Access Compliance Report

Public Rights-of-Way

Intersection ID: 11963	Main Street: S_GRAHAM_ST	Cross Street: W_4TH_ST	Location: N
ADA ID: 632826CC12D3	Ramp Type: Perp	Initial Pass/Fail: Fail	Overall Compliance: No
Severity Score: 13.75			
Codes/Mitigation Info/Possible Solution		Field Measurements/Component Compliance

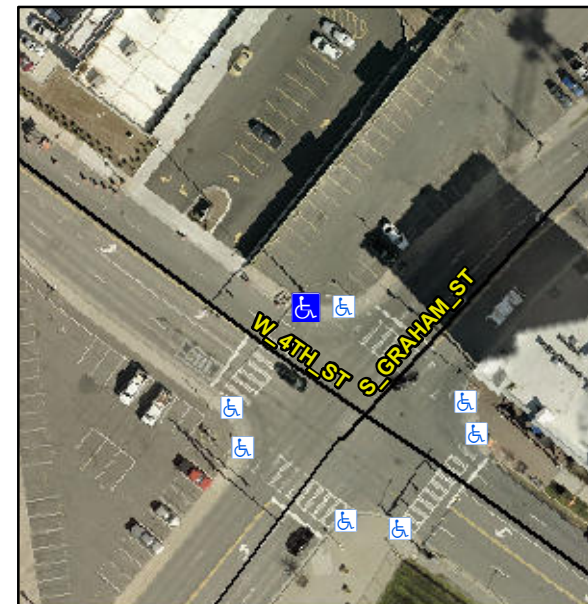
R304.2.2

Compliance	Description	Data	Compliance	Description	Data
N/A	Ramp Length (in)	72.0	No	Ramp Slope (%)	11.3
Yes	Ramp Width (in)	48.0	Yes	Ramp XSlope (%)	2.9
N/A	Flare Type LT	N/A	N/A	Flare Type RT	N/A
N/A	Flare Slope LT (%)	N/A	N/A	Flare Slope RT (%)	N/A
N/A	Flare Traversable LT?	N/A	N/A	Flare Traversable RT?	N/A
N/A	Landing Length (in)	N/A	N/A	DWS Provided?	N/A
N/A	Landing Width (in)	N/A	N/A	DWS Contrast?	N/A
N/A	Landing Slope (%)	N/A	N/A	DWS Length (in)	N/A
N/A	Landing X Slope (%)	N/A	N/A	DWS Full Width?	N/A
N/A	Landing Curb? (Y/N)	N/A	N/A	DWS Offset (in)	N/A
N/A	Shared Landing?	N/A			
N/A	Gutter Ponding?	N/A	N/A	Gutter Slope (%)	N/A
N/A	Gutter Lip Ht (in)	N/A	N/A	Gutter X Slope (%)	N/A
N/A	Painted X Walk1?	Yes	N/A	Painted X Walk2?	N/A
	X Walk 1 Direction	To SW		X Walk 2 Direction	N/A
N/A	X Walk 1 Width (in)	71.0	N/A	X Walk 2 Width (in)	N/A
	X Walk 1 Slope (%)	5.9		X Walk 2 Slope (%)	N/A
	X Walk 1 X Slope (%)	5.3		X Walk 2 X Slope (%)	N/A

Remove & Replace Entire Ramp.
